STAFF RECOMMENDATION
1608 16th Avenue South
May 17, 2017

Application: New construction – addition; Setback determination
District: South Music Row Neighborhood Conservation Zoning Overlay
Council District: 19
Map and Parcel Number: 10408035000
Applicant: Chris Gill
Project Lead: Sean Alexander, sean.alexander@nashville.gov

STAFF RECOMMENDATION
1608 16th Avenue South
April 19, 2017

South (right side) elevation of existing house and proposed addition.

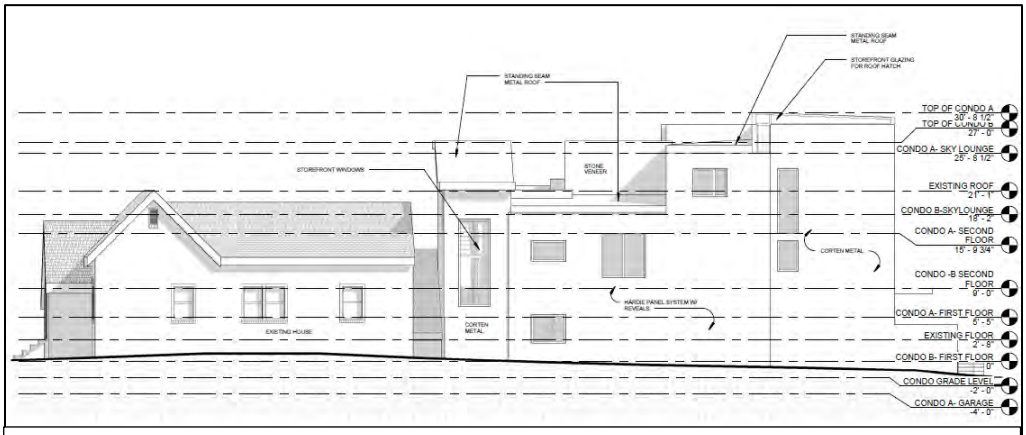
<u>Height, Scale & Building Shape</u>: The addition will have a split-level shape, with two levels in the front unit and two and a half in the rear, with roof decks on both units. The roof of the front unit will be two feet (2') lower than the roof of the house and the roof of the rear unit will be four feet, six inches (4'-6") taller. The taller roof section begins seventy-seven feet (77') back from the front of the building. In addition to the taller roofs the addition will have a stair tower and a railing on the roof deck that extend to six feet (6') and eight feet (8') taller than the original roof, respectively. Additions more than four feet (4') taller than an historic house are generally not considered appropriate; however, in this case Staff finds the proposal to be appropriate because the impact on the

historic house is minimal and because the addition is set so far to the rear. Furthermore, the composition of South Music Row is unique in that it was historically a residential neighborhood but many of the buildings have been used and adapted for other uses since the 1950s. The broader Music Row area is a mix of office and multi-family buildings in a variety of forms from a variety of eras. Rear yards in this district are typically parking areas so the Commission, in the past, has approved new construction that takes up the more area of the lot than would be appropriate elsewhere. The depth of the addition will be fifty feet (50') and the footprint area will be approximately thirteen hundred square feet (1,300 sq. ft.), roughly equaling the depth and area footprint of the existing house.

Considering the unique history and complex character of the overlay and the minimal impact of the addition proposed, Staff finds that the project meets section II.B.1.b and II.B.1.c of the design guidelines.

Location & Removability: The addition will connect to the existing building at the rear wall, stepped in eight feet (8') from the existing house on the right side and six feet (6') on the left. The addition steps back out to both sides behind a four foot (4') deep hyphen, and it will remain in line with the right side of the house but extend four feet (4') wider on the left. Although wider than the original building, the location of the addition at the rear of the existing building is in accordance with the design guidelines because of the insets, as the separate form helps to distinguish it from the historic house and clearly read as an addition. The addition is designed so that if the addition were to be removed in the future, the historic character of the house would still be intact. Staff finds the proposal to meet section II.B.2.a and II.B.2.b of the design guidelines.
